PUBLIC COMMENT on PROPOSED BUILDING STANDARDS
For Publication in Title 24, California Code of Regulations

Title 24 Part #: (select one) Part 1 Section #: Ch. 2 (Item 2.03)

Proposing State Agency DSA-AC

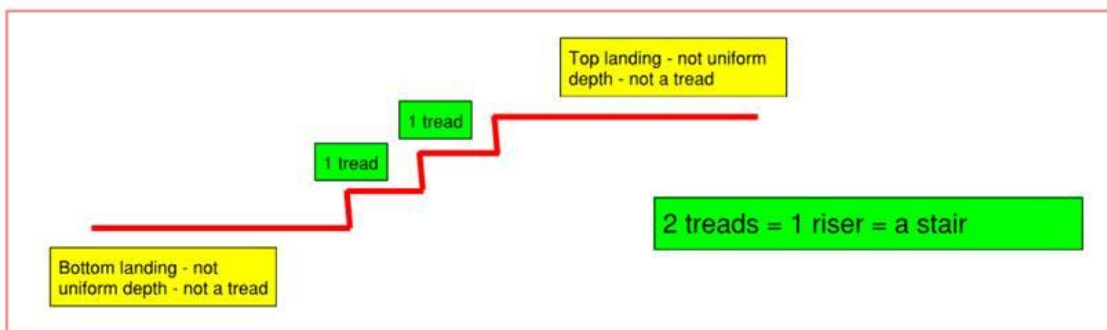
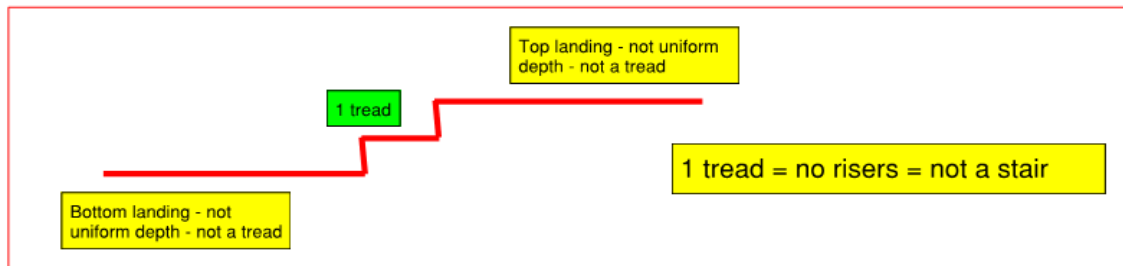
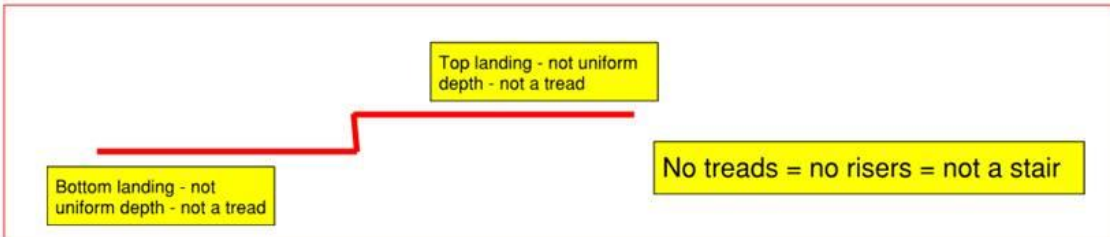
2. Currently, per the CBC, a STAIR must contain a minimum of 3 vertical rises, which I shall explain below.

Per the standards, stair treads must have a uniform depth. As such a stair's top and bottom landings do not qualify as treads. By definition, where there are no treads, there are no risers; and where there is no riser, there is no stair. The graphics below illustrate the results of this line of thinking.

Admittedly, this is not "the common understanding", but it is what the CBC requires. And while the 2010 ADA Standards is not so precise, the above result does not conflict with what it requires.

Based on this, the proposed changes result in an increase in the CBC's (and the ADA Standards') requirements for accessibility.
